**From:** Spink, Thomas E [tespink@tva.gov]  
**Sent:** Monday, August 25, 2008 12:52 PM  
**To:** Mallecia Hood  
**Cc:** Sterdis, Andrea Lynn; Neil Haggerty  
**Subject:** Courtesy email copy of TVA's Response to Environmental Report - Letter 22A - CORMIX-RELATED HYDROLOGY INFORMATION - Corrected attachment  
**Attachments:** ER Ltr 22A - CORMIX Aug. 22.Final pdf.pdf

BELLEFONTE COMBINED LICENSE APPLICATION – RESPONSE TO  
ENVIRONMENTAL REPORT REQUEST FOR ADDITIONAL INFORMATION – CORMIX-  
RELATED HYDROLOGY INFORMATION

ENCLOSURE  
RESPONSE TO ENVIRONMENTAL REPORT REQUESTS FOR ADDITIONAL INFORMATION  
CORMIX-RELATED HYDROLOGY INFORMATION

**NRC RAI NUMBER: 5.2-5, 5.3-3(2), 5.3-3(3), 5.3-5, and 5.3-8**

**Attachment 5.3-3(1)F**  
**BLN Flow Rate Response (May 2-3, 1983)**  
**Compared to Guntersville and Nickajack Dam Releases**

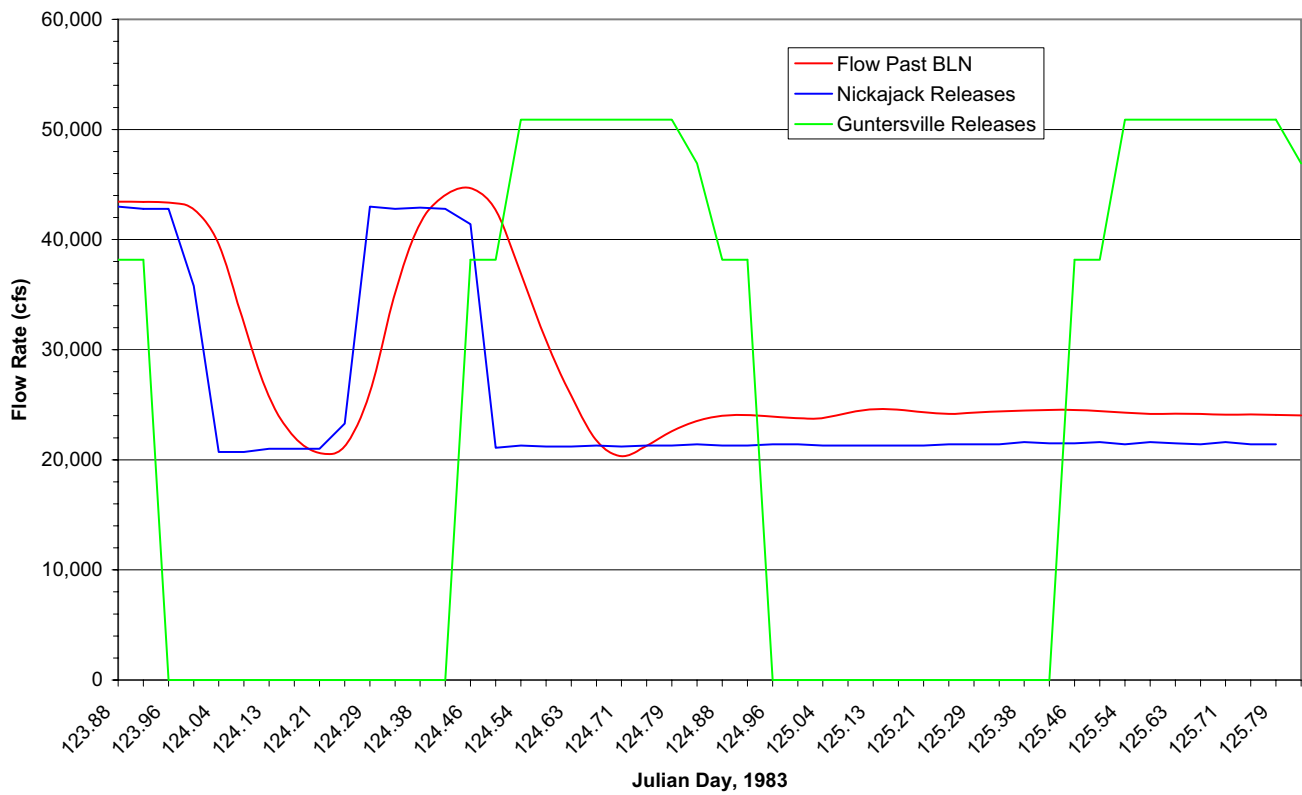
- 5.3-2:** (1) Provide the CORMIX output files for the ER Rev0 CORMIX analyses.
- (2) Provide a description and data associated with definition of “reversing river flow”, and “maximum reverse river flow”, e.g., the river discharge values employed in the analyses.
- 5.3-3:** (1) Provide data or an analysis of flow reversal at the Bellefonte site that better characterizes the flow reversal phenomena. Use the existing reservoir operation rules and any future anticipated changes to peaking strategy to evaluate these phenomena.

In general, flow past the BLN site seems to be most influenced by the releases from Nickajack Dam. Discharges from Guntersville Dam seem to have minimal effect on the flow rate past the BLN [Attachments 5.3-3(1)F and 5.3-3(1)H]. These curves show the flow reversals are generally a response to lowering or cessation of flow from Nickajack Dam and tend to show an oscillatory response during longer periods of zero dam discharges [Attachments 5.3-3(1)E and 5.3-3(1)I]. None of the oscillations produced extended periods of low flow, even during times where neither dam was discharging.

FIGURE 5.3-3  
100% EFFLUENT FLOW THROUGH BOTH  
DIFFUSERS - 7Q10 RIVER FLOW (39.2°F)

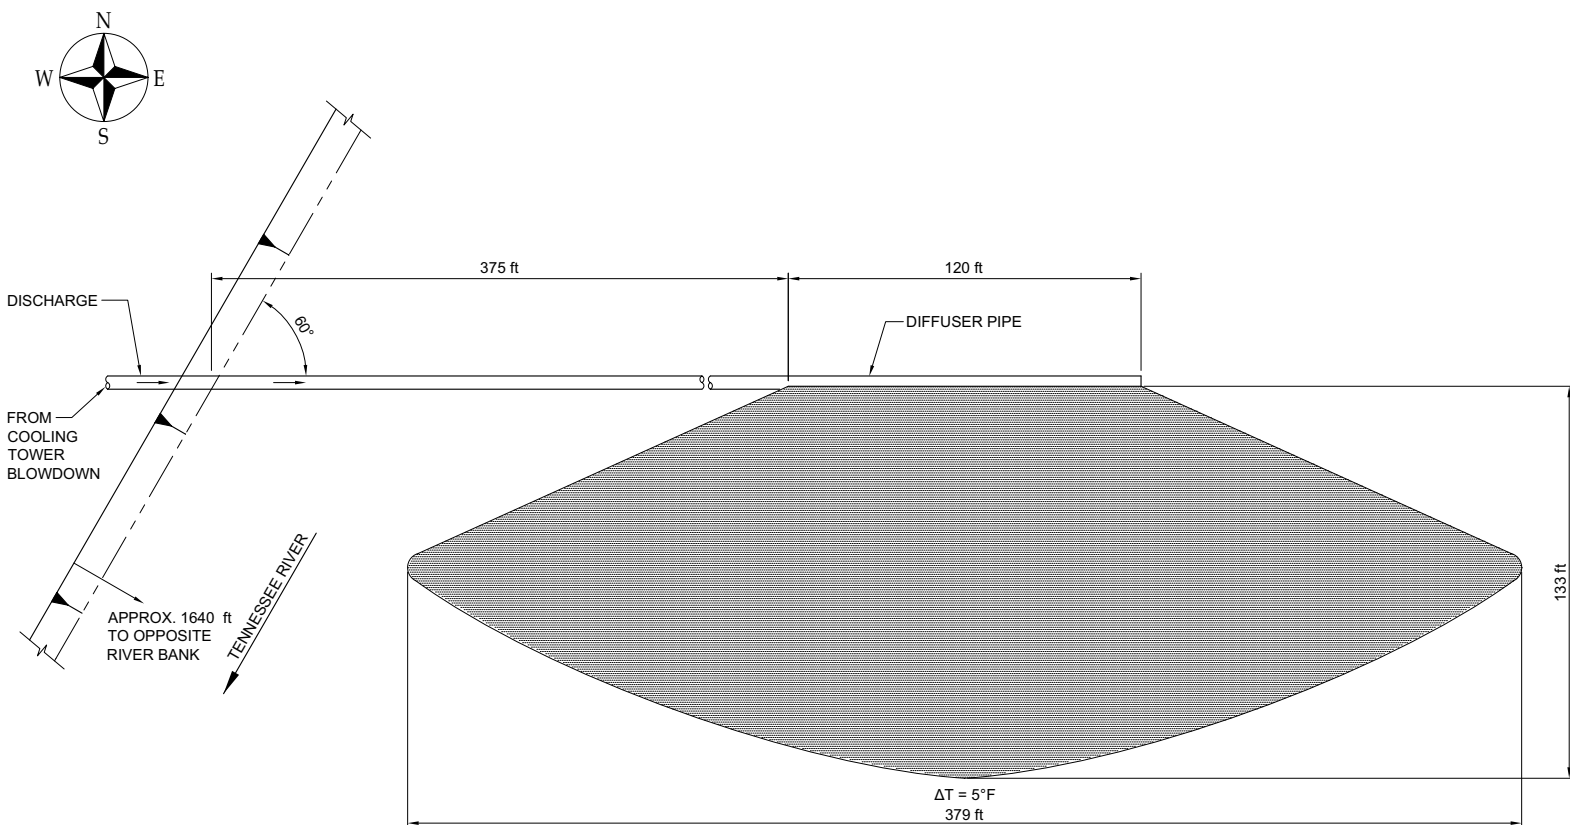
- 5.2-5:** Provide a description of all nine CORMIX cases analyzed to understand the potential impact of discharge on the Tennessee River.
- 5.3-3:** (2) If results of the flow reversal warrant them, provide revised descriptions of the CORMIX runs that characterize the operation of the diffusers.
- (3) If additional CORMIX simulations are conducted, provide their input and output files.
- 5.3-5:** (1) Review and revise Figures 5.3-3 through 5.3-11; for clarity, draw them all to scale or none to scale.
- (2) For these figures, use a consistent unit convention (English or Metric).
- 5.3-8:** Provide a referenceable, consistent, and complete discussion of the analysis and assumptions leading to the single pipe simulation (including the results of such simulation(s) appearing in the ER) for diffuser operation.

- Low river temperature, 7Q10 downstream flow (Figure 5.3-3)
- High river temperature, 7Q10 downstream flow (Figure 5.3-4)
- Low river temperature, reversing river flow \*
- High river temperature, reversing river flow \*
- Low river temperature, maximum reverse river flow (Figure 5.3- 5)
- High river temperature, maximum reverse river flow \*
- Low river temperature, maximum downstream flow \*
- High river temperature, maximum downstream flow \*

7. Change COLA Part 3, ER Chapter 5, by **replacing existing** Figure 5.3-3, Rev. 0, **with Figure 5.3-3, Rev. 1**, 100% Effluent Flow through Both Diffusers – 7Q10 River Flow (39.2°F), provided as Attachment 5.3-5A.
8. Change COLA Part 3, ER Chapter 5, by **replacing existing** Figure 5.3-4, Rev. 0, **with Figure 5.3-4, Rev. 1**, 100% Effluent Flow through Both Diffusers – 7Q10 River Flow (90°F), provided as Attachment 5.3-5B.
9. Change COLA Part 3, ER Chapter 5, by **replacing existing** Figure 5.3-5, Rev. 0, **with Figure 5.3-5, Rev. 1**, 100% Effluent Flow through Both Diffusers – Maximum Reverse River Flow (39.2°F), provided as Attachment 5.3-5C.
